## STAFF RECOMMENDATION

228 Chapel Avenue

October 17, 2012

**Application:** Full demolition; New construction-infill; Setback reduction

1 PROPERTY PLAN  
 SCALE 1/32" = 1'-0"

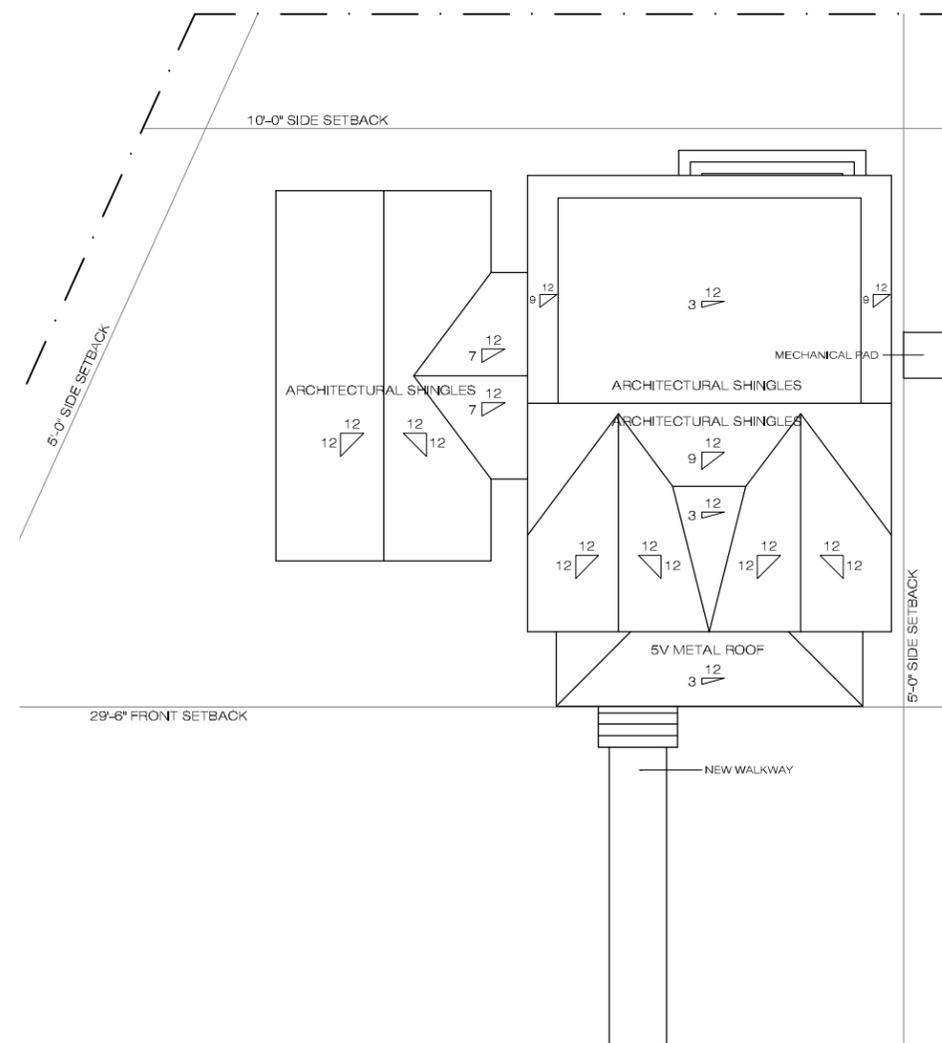
The front edge of the new building would be aligned with the adjacent historic house to the right, and the side setback yard on that side would be six feet (6'). On the left side, the setback would vary along the angled street but would be no less than thirteen feet (13') at any point. The massing of the new building and proposed setbacks are in keeping the rhythm of spacing established by houses along Chapel Avenue, which currently breaks at the intersection with Benjamin Street. The proposed new structure would meet the minimum setback buffer requirements on the front and both sides, but due to the size of the lot it would not meet the rear setback. Therefore a reduction of the rear setback from twenty feet (20') to ten feet (10') is requested. Because of the shallowness of the lot which does not have a rear alley, and because maintaining the required rear setback would render the lot unbuildable, staff finds the proposed setback to meet guideline II.B.1.c.

1 FRONT ELEVATION  
SCALE 1/8" = 1'-0"

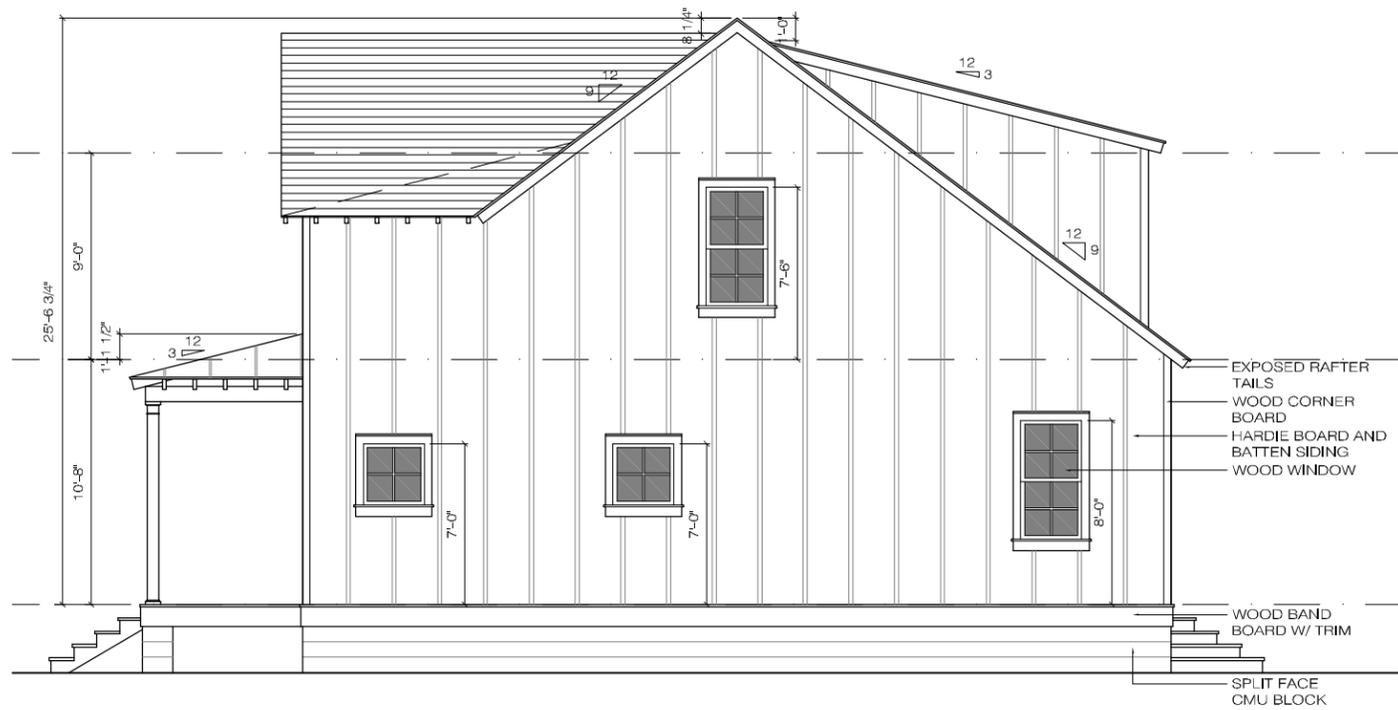
The proposed new house will have two components: a two-story main component and a left-side, one-story wing. The two-story component will be twenty-nine feet (29') tall with an eave height of twenty feet (20'). The finished floor level will be three feet (3') above grade, with a two-foot (2') tall foundation and a one foot (1') wide water table band. This is similar to the foundation heights of surrounding historic structures. The building will have a complex roof form with a primary side-gabled roof with two engaged front gables and a shed-roofed rear dormer. The footprint of this component will be thirty feet (30') wide across the front and thirty-eight feet (38') deep, with a seven foot (7') deep porch across the front.

The materials of the new structure will include: cement-fiber board and batten siding, a split-faced concrete block foundation, and a composite shingle roof ("weathered wood or gray-brown color). The roof on the front porch will be metal, of which the color is not yet known but could be approved by staff. The trim and windows will be wood, although additional information about the windows (ex. muntin type) and doors should be approved by staff prior to purchase. If a porch railing is added to meet Code, it should also be approved by Staff. With the conditions that the information on the windows doors, porch roof, and any added railings be approved prior to purchase or installation, staff finds the materials to meet guideline II.B.1.d.

The primary gabled roof of the two-story component will have a 9:12 pitch, while the other gables will have a 12:12 pitch. The front porch will have a metal hipped roof with a 3:12 pitch. These roof forms and pitches are very common among historic houses in the area and meet guideline II.B.1.e.

1. The color of the porch roof is approved by Staff; and
2. Front porch railings, if needed, shall be approved by Staff; and
3. Additional information on the windows and doors is approved by Staff.

1 SIDE ELEVATION  
SCALE 1/8" = 1'-0"

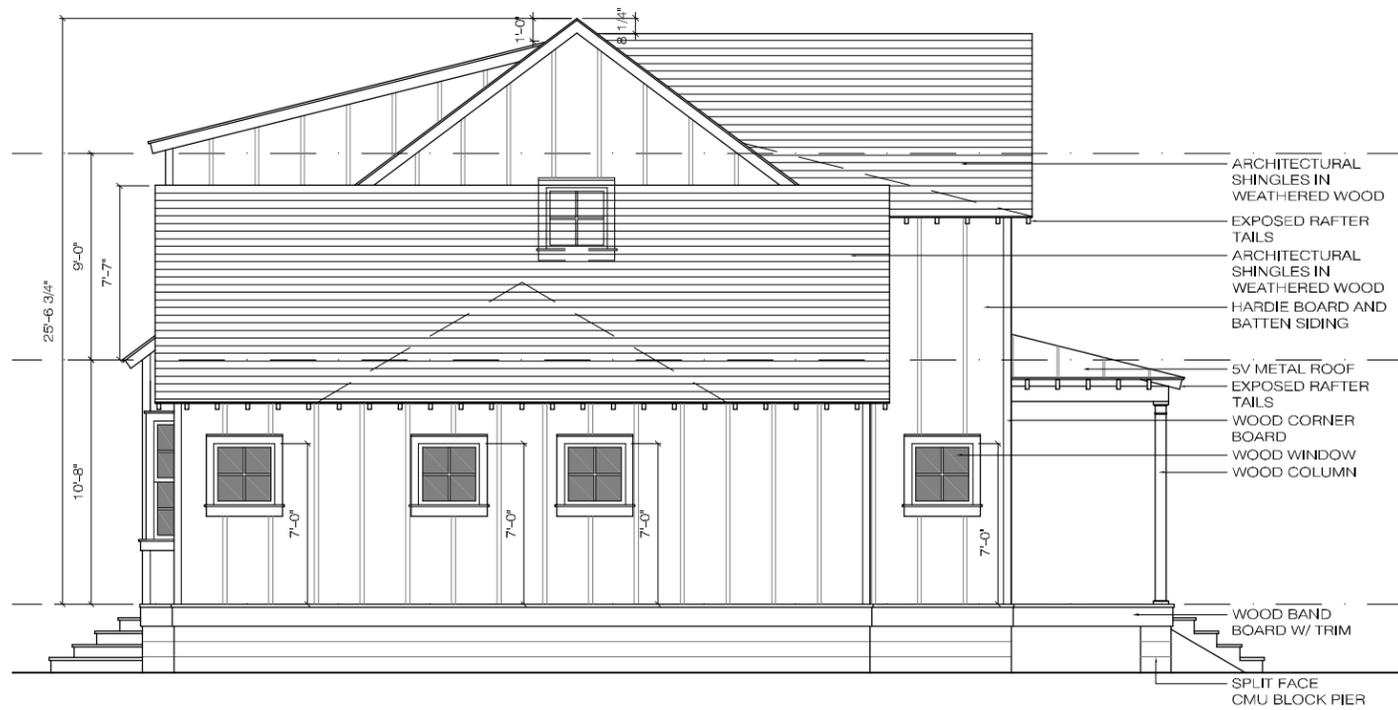
All four elevations of the structure will have evenly spaced windows, most of which will be roughly twice as tall as they would be wide. The remaining windows including three facing Benjamin Street in the one-story wing of the house would be square. In this instance, the shortened windows are appropriate relative to the scale of the one-story wing, which is shorter than the two-story wing that has taller windows. Staff finds the overall proportion and rhythm of window openings to meet guideline II.B.1.g.
